PLAN COMMISSION AGENDA

Memo

Re: Agenda Item 6a: Preliminary Plat – Kimberly Heights

Preliminary Plat of Kimberly Heights

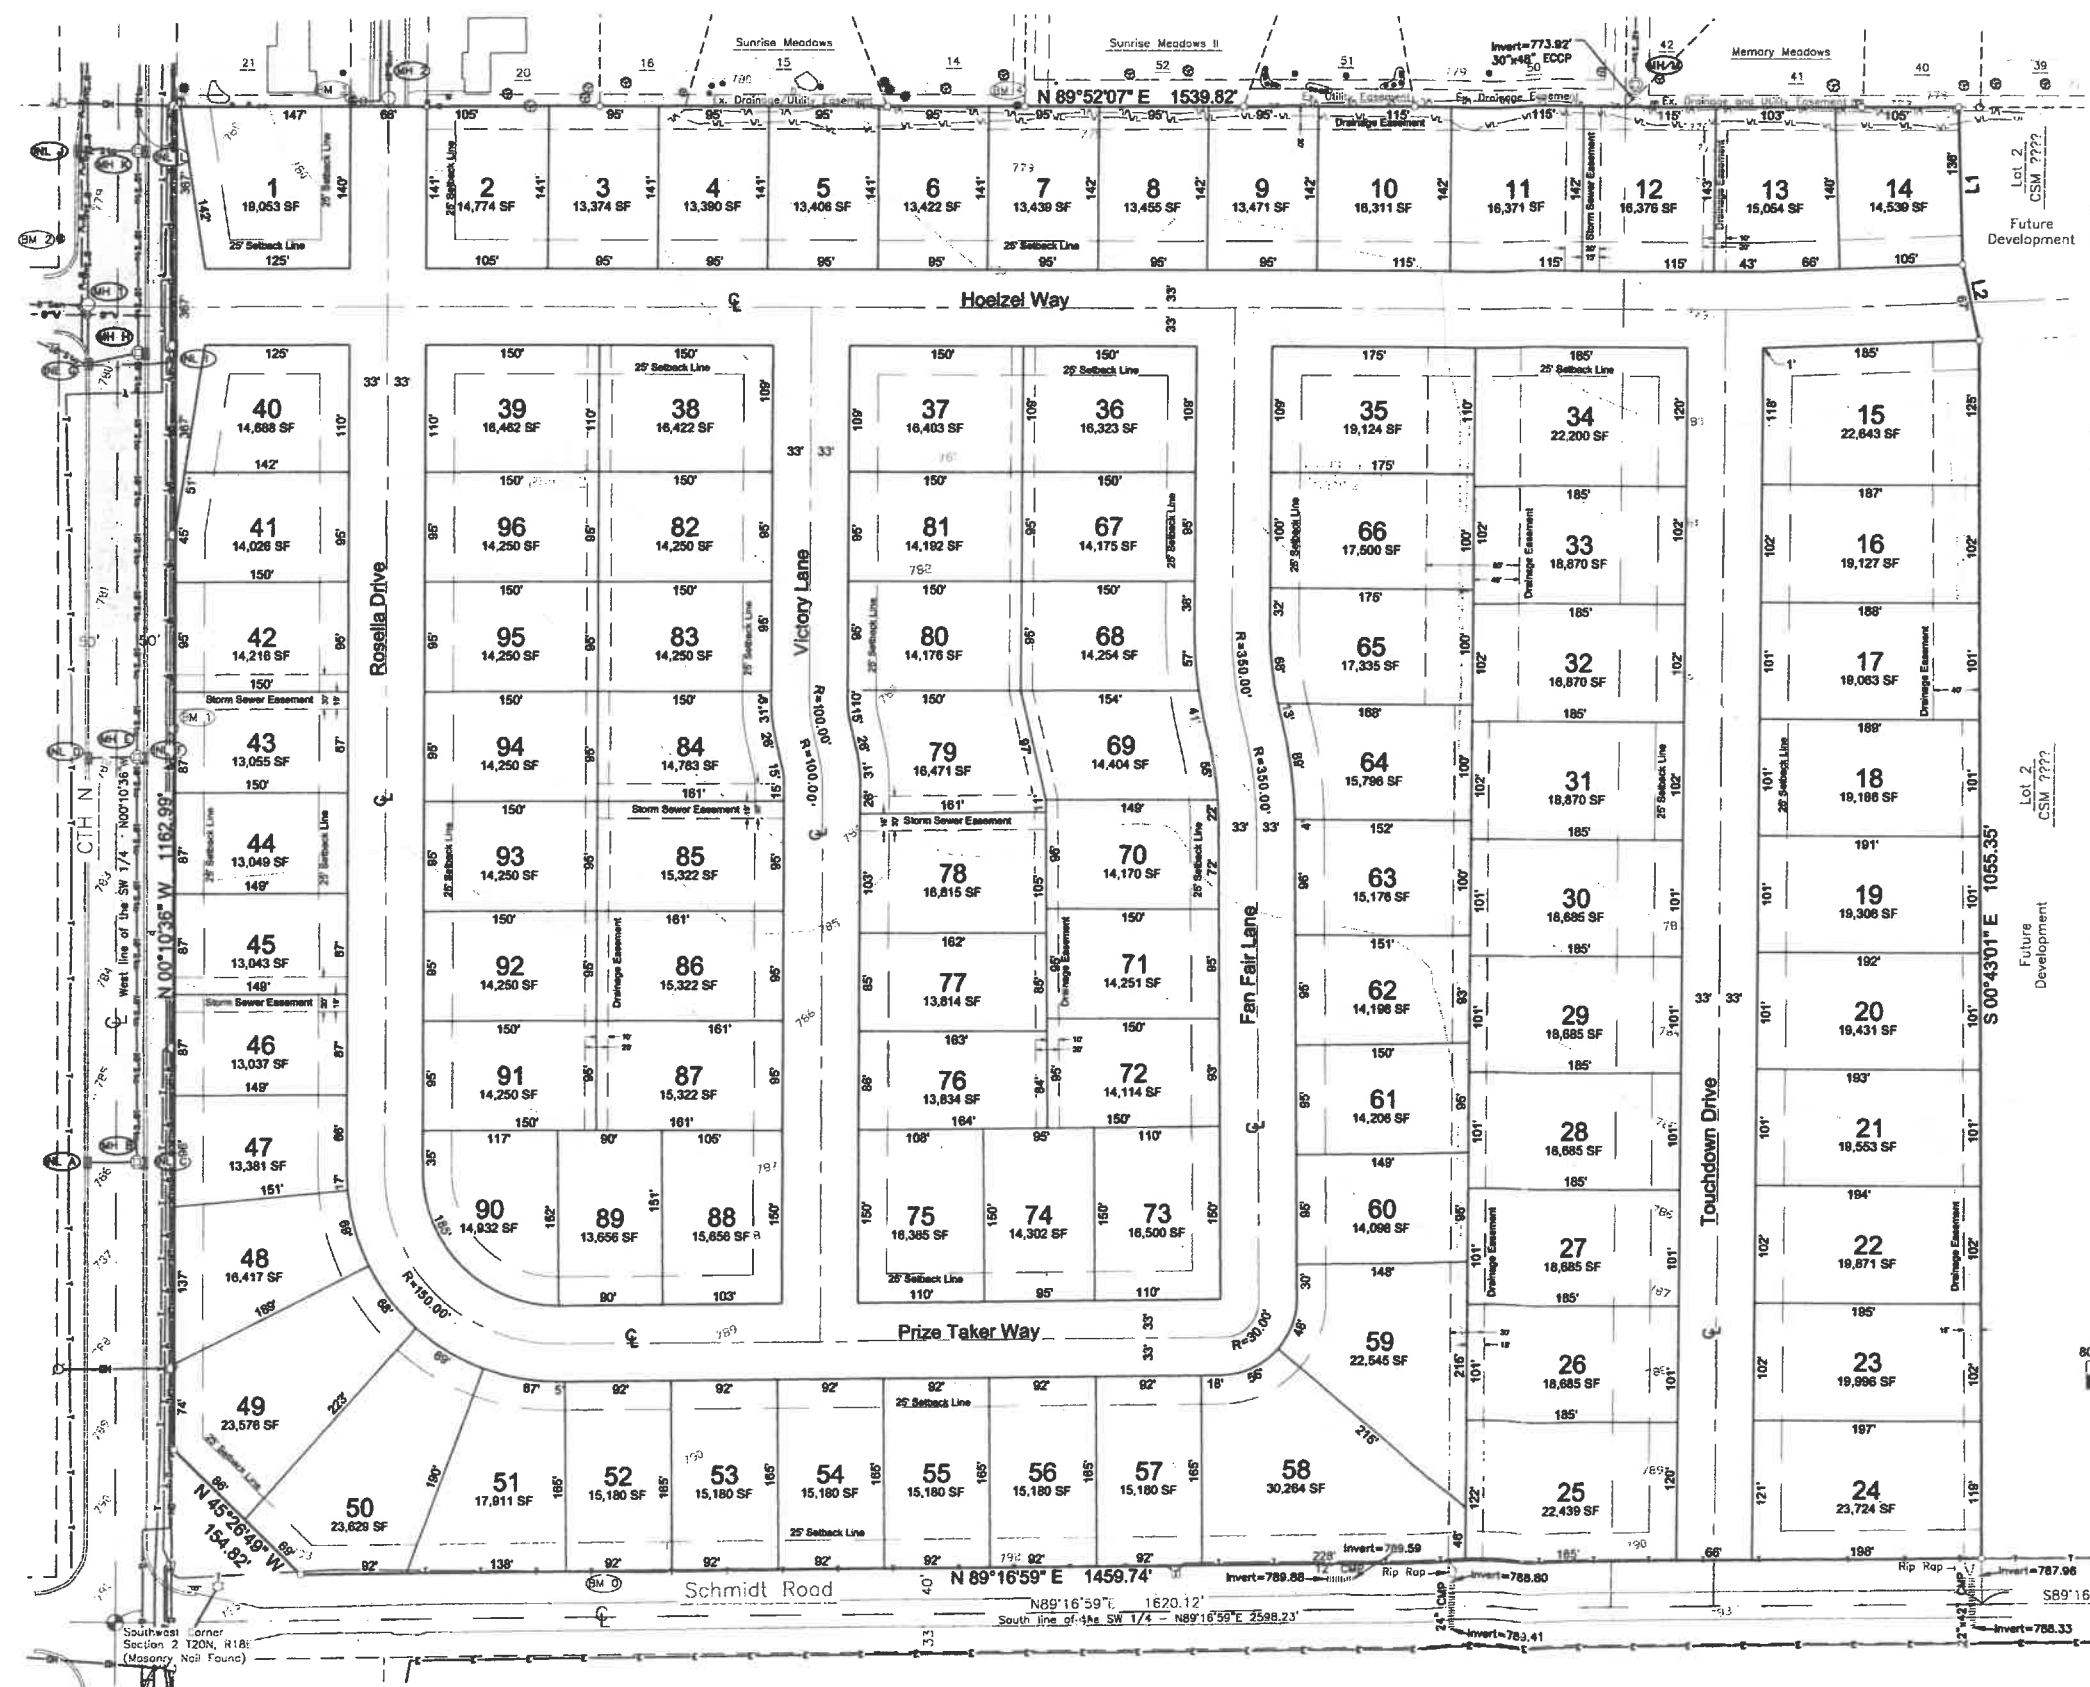
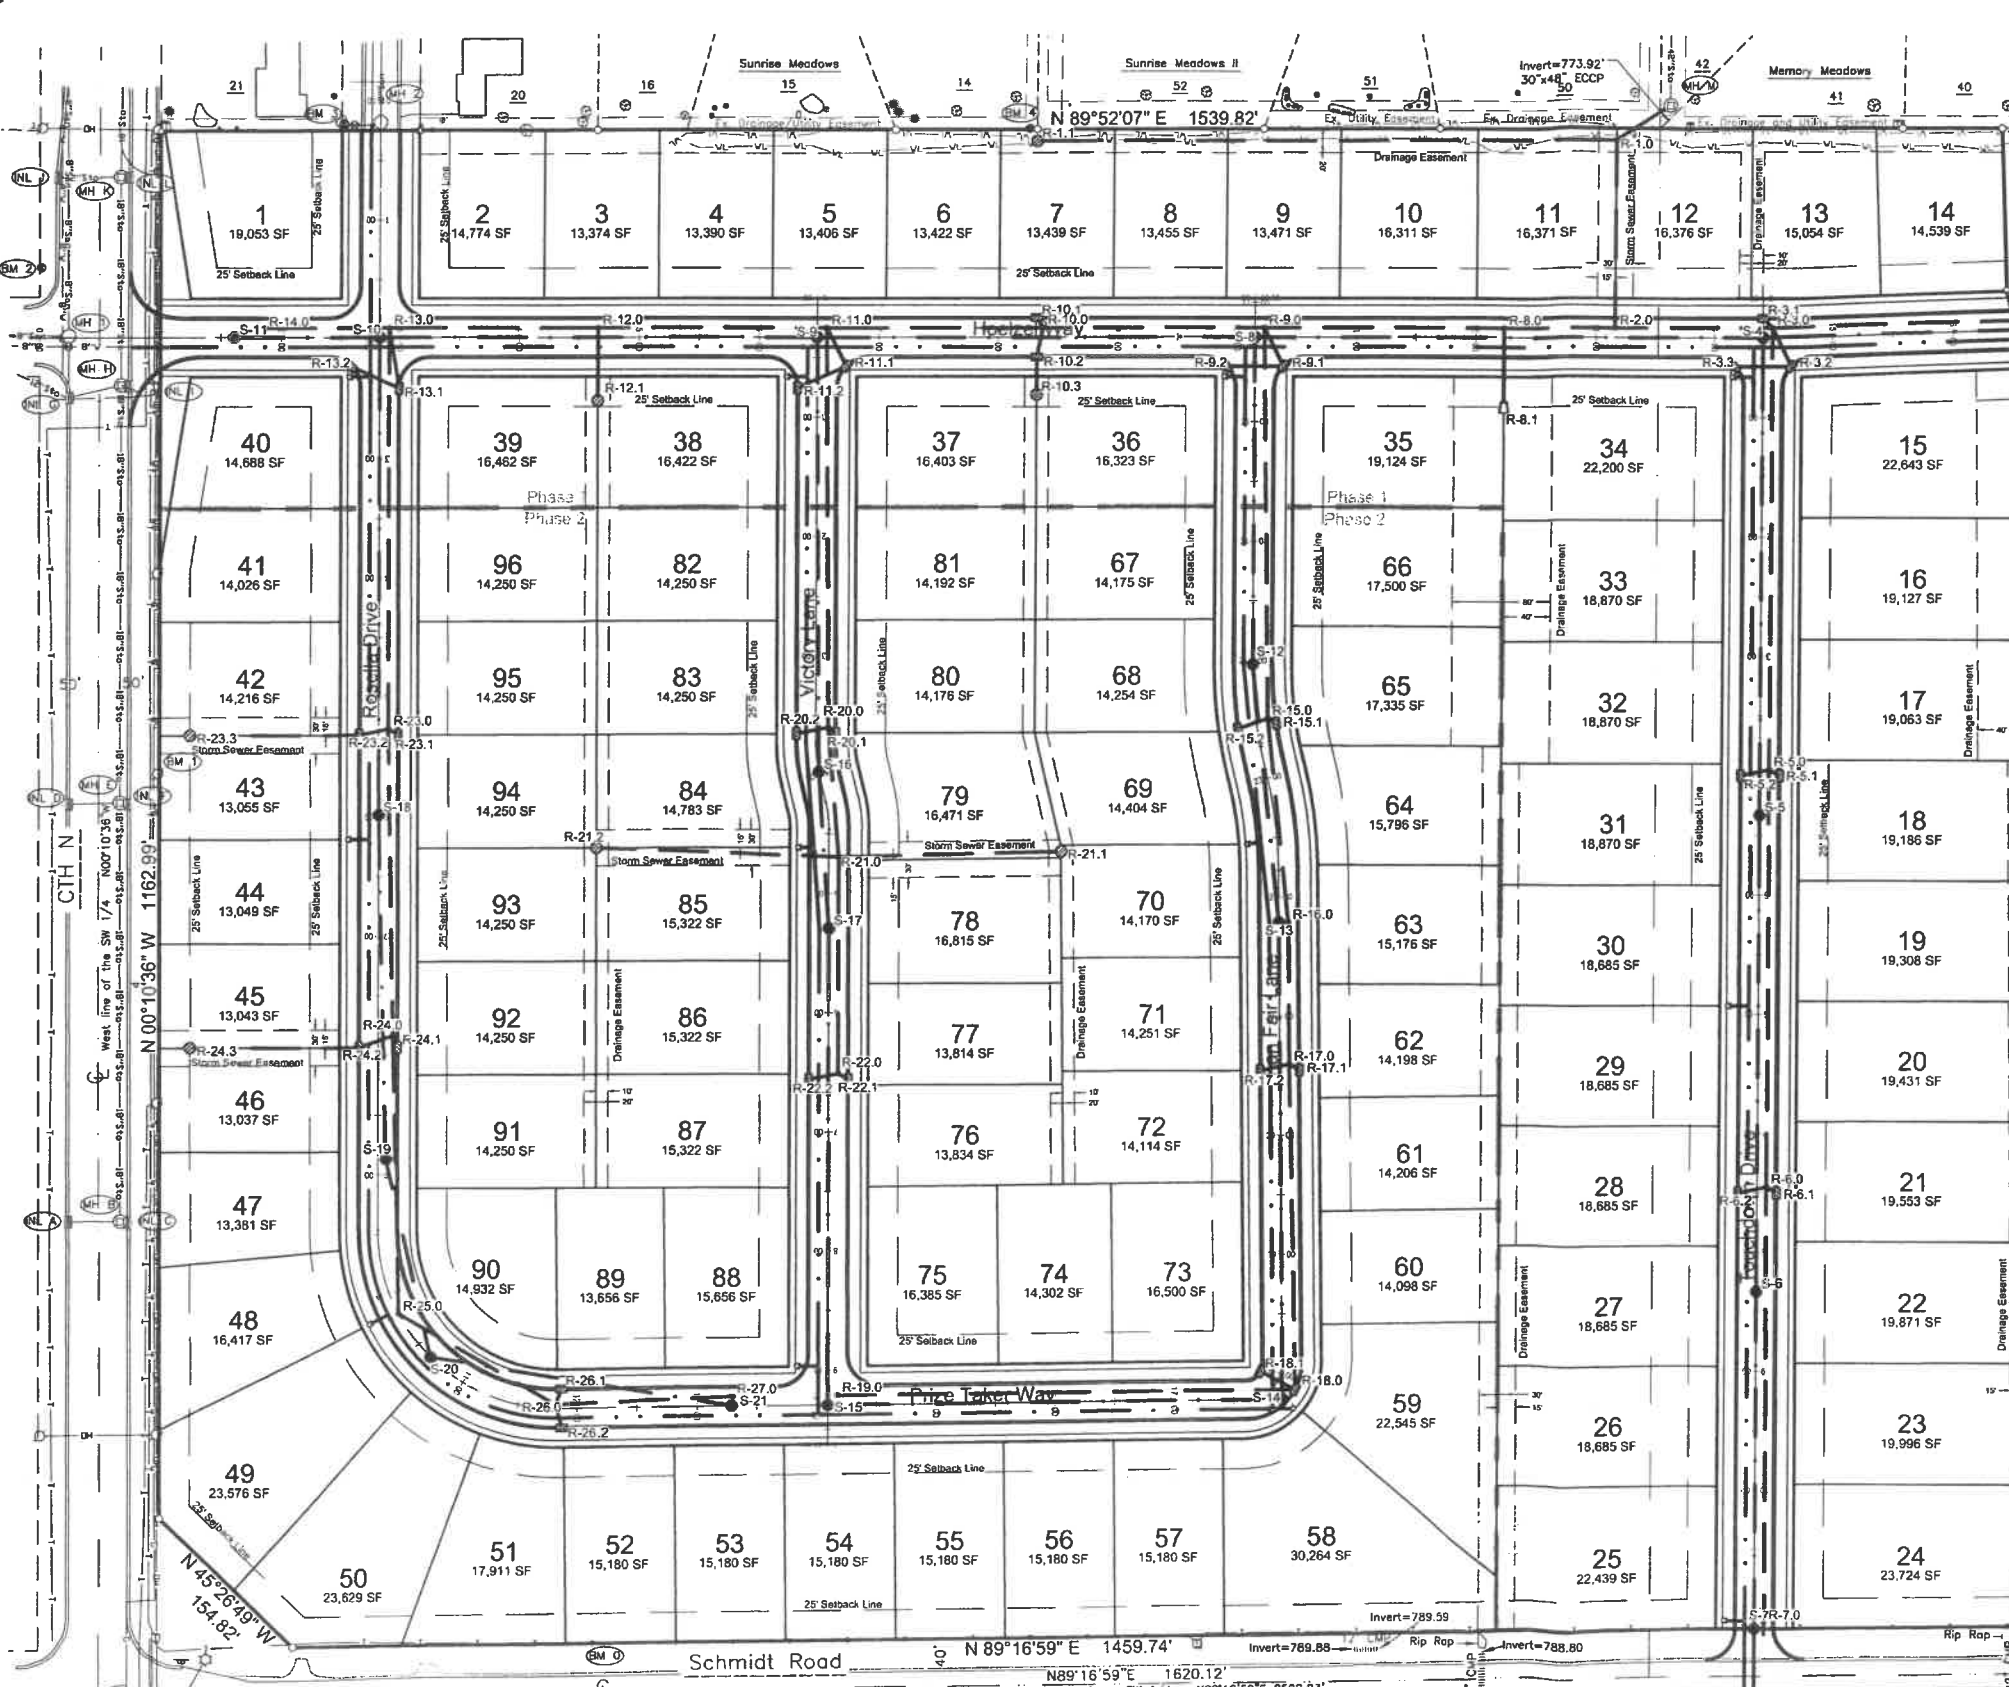
Staff recommends approval of the Preliminary Plat of Kimberly Heights with the following conditions:

1. A zoning map amendment (rezoning) shall be submitted to rezone the property from General Agricultural [AG] to Single-Family Residential (Suburban) [RS-1].

2. A "12' Utility Easement" shall be granted to include the Darboy Sanitary District as a Grantee for the purposes of maintenance, repair, and/or replacement of sanitary or water infrastructure and access thereto.

12. Wetland determinations and/or studies shall be provided to the Village.
13. A note shall be added to the plat indicating access control to County N and Schmidt Road.

14. A note shall be added to the final plat indicating that the Village of Harrison will assess all lots for street improvements, including but not limited to, curb & gutter, concrete pavement, and sidewalks.

18. Benchmarks shall be established on all hydrant tag bolts.
19. All environmental corridors shall be clearly identified and setback lines to be indicated.

20. Temporary turn-around to be provided on dead-end streets longer than 150-feet.
21. A 25-foot easement for a landscaping berm and plantings shall be added to the final plat. Details on the berm design and plantings shall be indicated in the final plans.

24. All road names shall be approved by the Appleton Post Office, the Village of Harrison, and Calumet County E911.

TYPICAL STREET SECTION
66' Right of Way (Emily Lane, Parker Way, Mase Court)

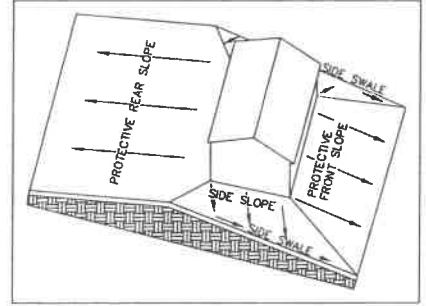
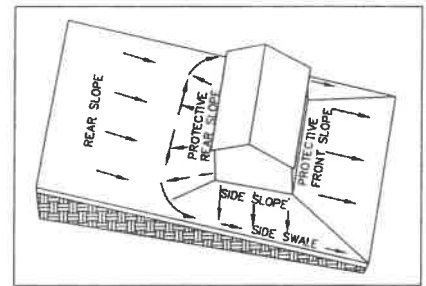
10. Typical Street Section to be in accordance with the Village of Harrison Standard Specifications Manual for Concrete Streets.
11. High-back, integral concrete curb shall be utilized rather than the mountable curb.

Re: Agenda Item 7a: Lot Split – Zirbel Drive

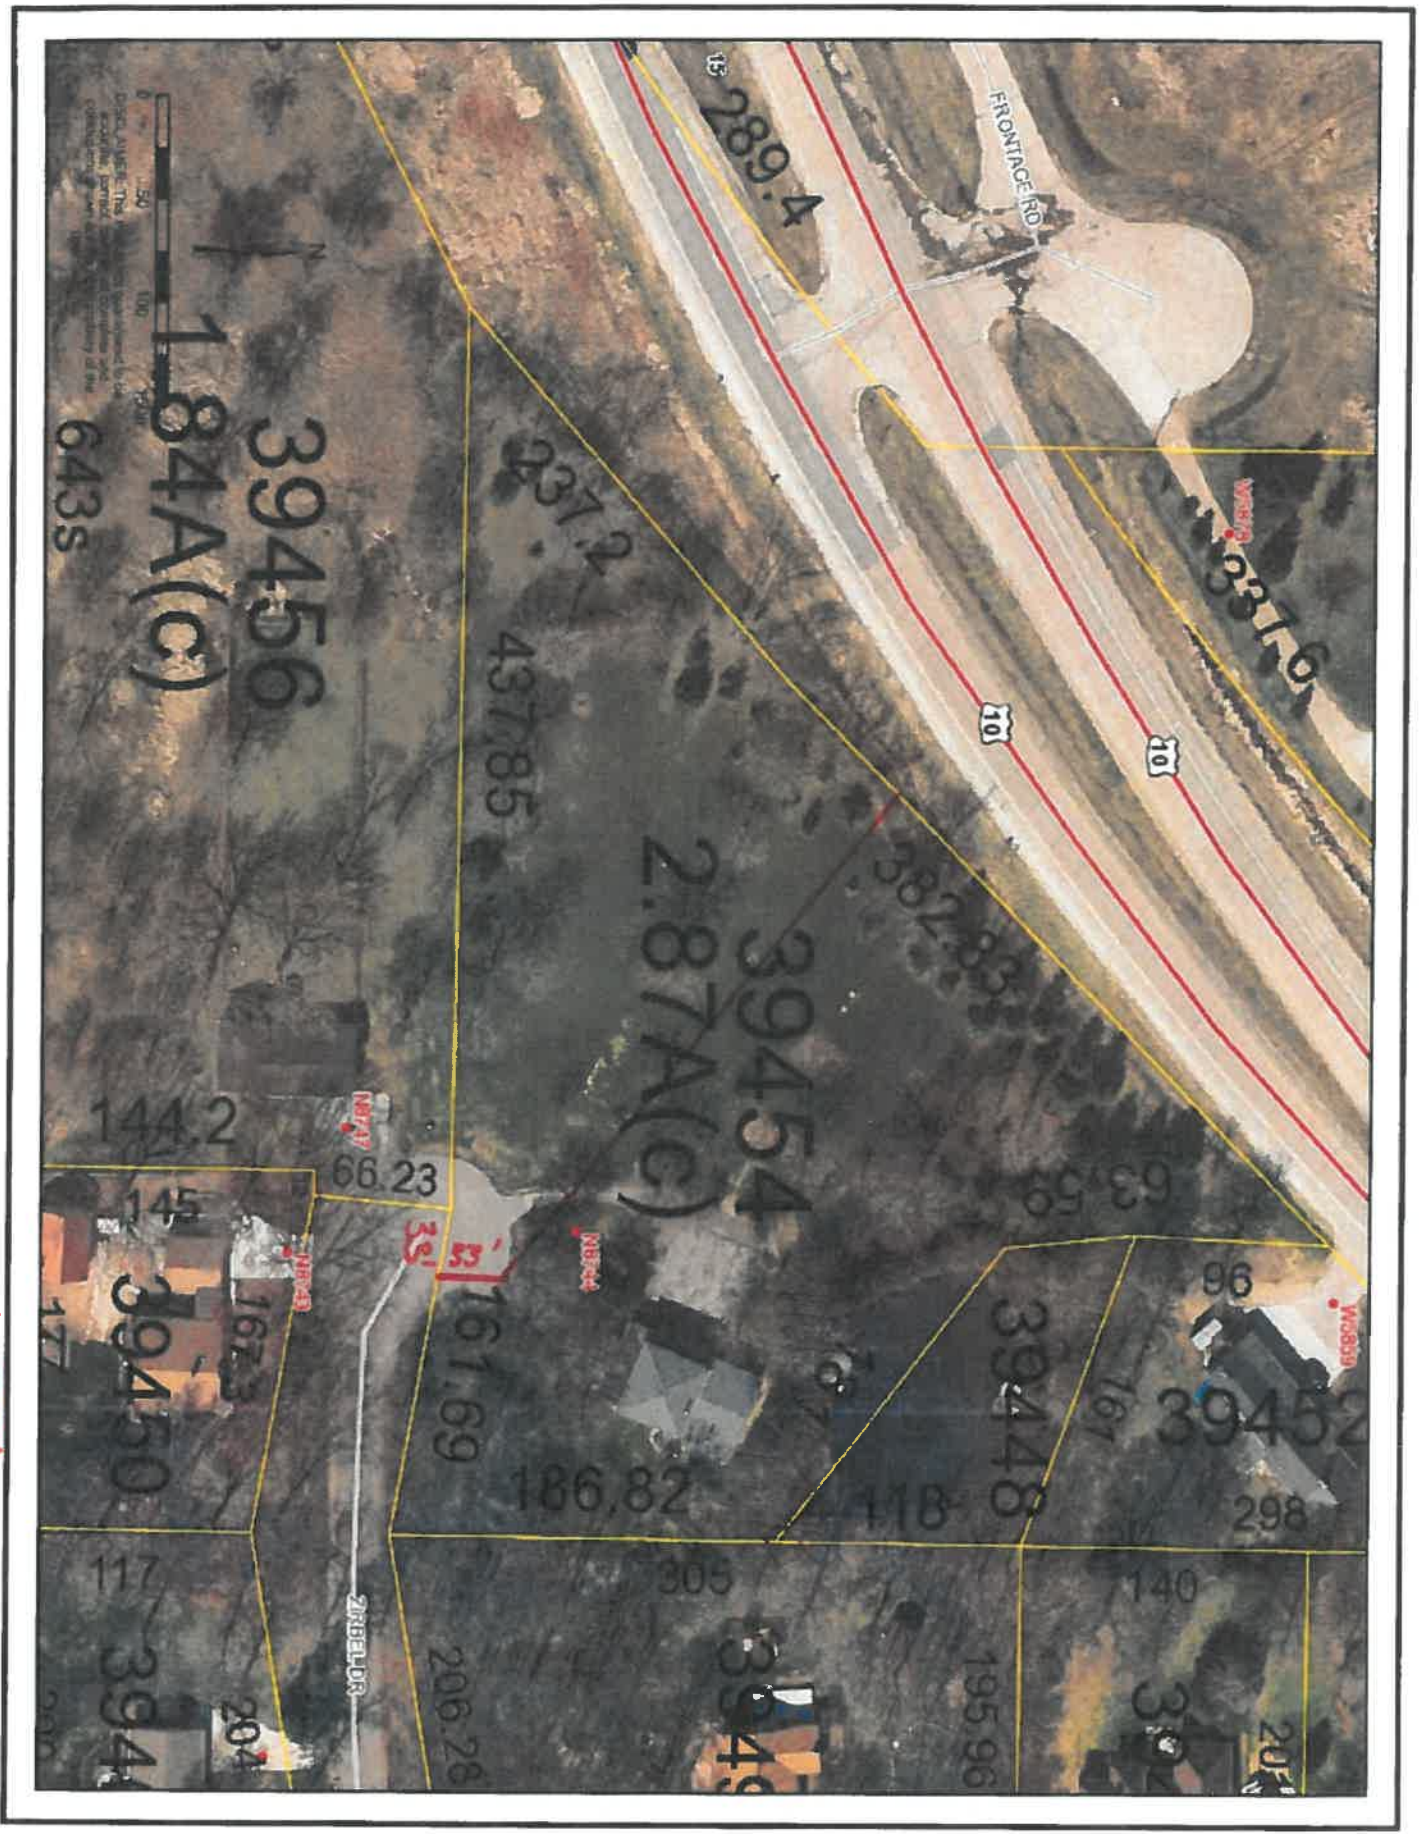
The zoning ordinance requires a minimum of 80-feet of road frontage for all lots in the RS-1 zoning district. There is an exception to allow only 33-feet for flag lots. Staff does not feel that this lot qualifies as a flag lot. Additionally, creating 2 lots with 80-feet of road frontage may create awkward angled lots. Staff does not recommend splitting this property.

The Plan Commission is being asked to provide feedback/comments on the proposed lot split.
